SOUTHERN UTAH FUEL COMPANY MINE NO. 1 MINE PLAN
HYDROLOGY SECTION ADDITION

June 5, 1981

RESPONSE TO APPARENT COMPLETENESS REVIEW
SOUTHERN UTAH FUEL COMPANY
ACT /041/002
SEVIER COUNTY, UTAH

RESPONSE TO APPARENT COMPLETENESS REVIEW
SOUTHERN UTAH FUEL COMPANY
CONVULSION CANYON MINE
ACT /041/002
SEVIER COUNTY, UTAH

FIGURE 1. Flow Hydrograph Station 006, South Fork Quitcupah Creek from June to November, 1980	12
FIGURE 2. Flow Hydrograph Station 007, North Fork Quitcupah Creek from June to November, 1980	12
FIGURE 3. Flow Hydrograph Station 042, North Fork Quitcupah Creek from June to November, 1980	13

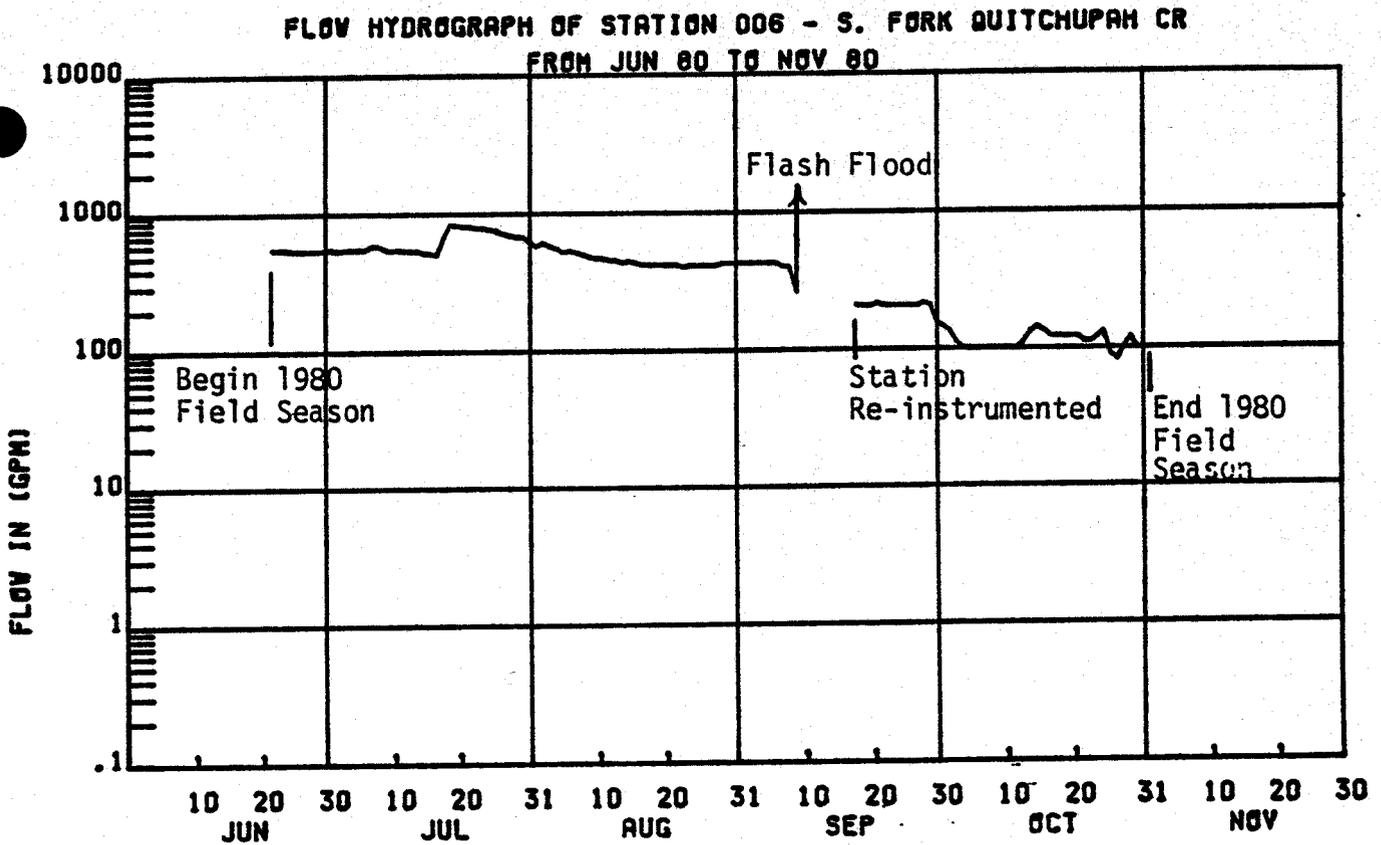
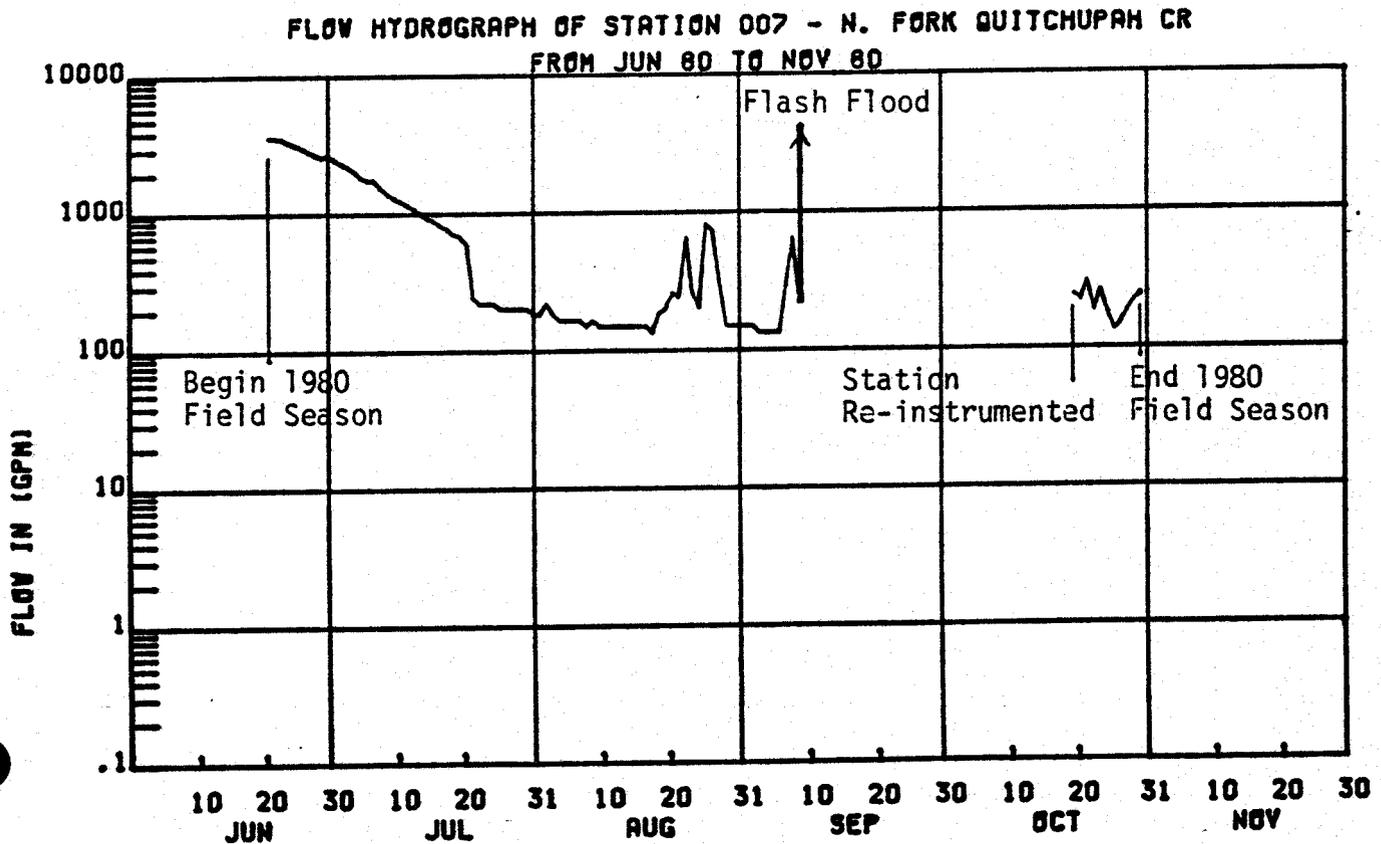
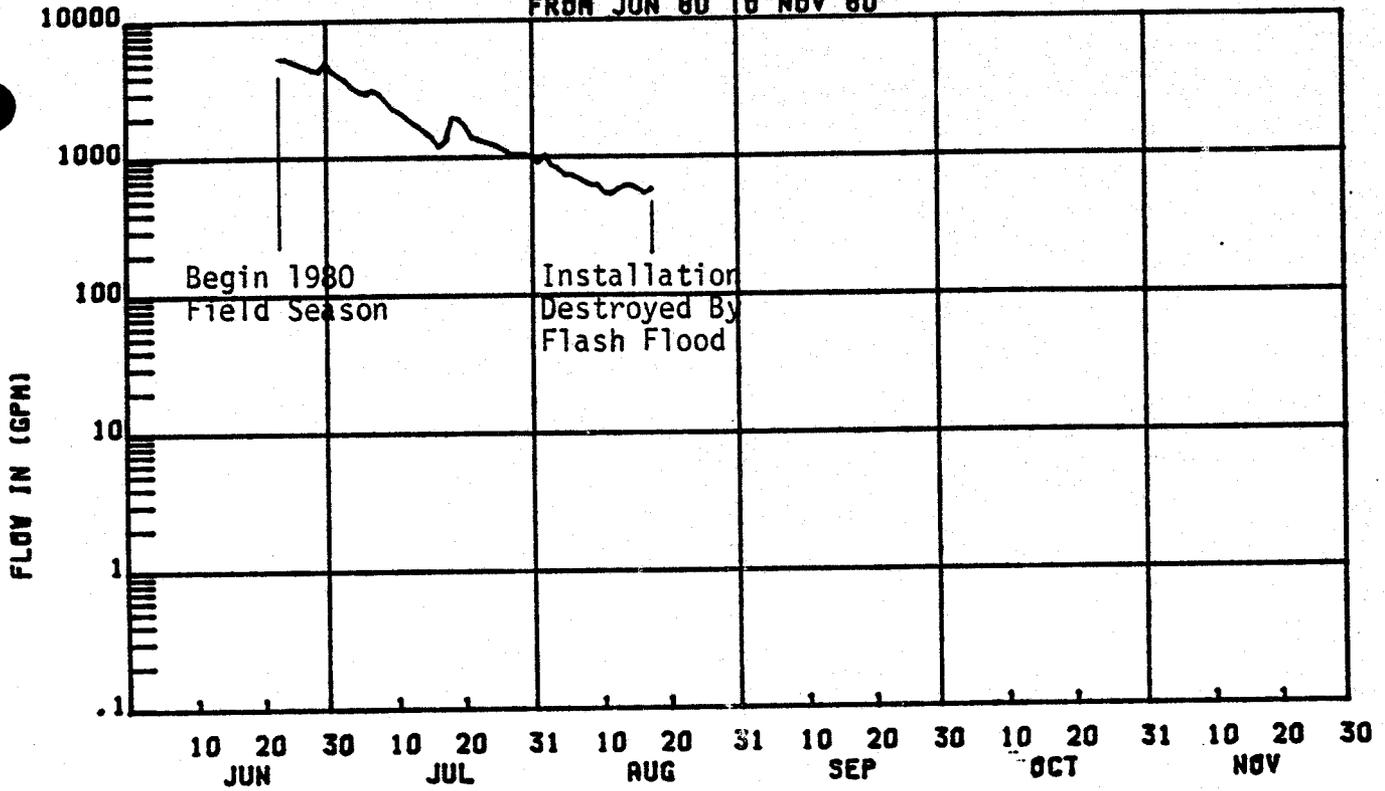
(b)(3) Applicant should present an adequate surface and groundwater monitoring plan for operational and postmining periods. Will the same schedule be utilized as for baseline monitoring? What is the monitoring frequency of the two springs identified within the mine?

Three streamflow gaging stations using flumes have been installed in the vicinity of the mine to depict seasonal variation in streamflows. These stations were instrumented in 1980 (June through November) and again in 1981 with Leupold Steven Type F-1 water level recorders. Recorders typically cannot be installed before June because roads are impassable. Recorders are removed during winter months because there is no access and flow measurements would not be accurate because of freezing problems. Peak flows which scour out and remove flume installations have been a particular problem at the
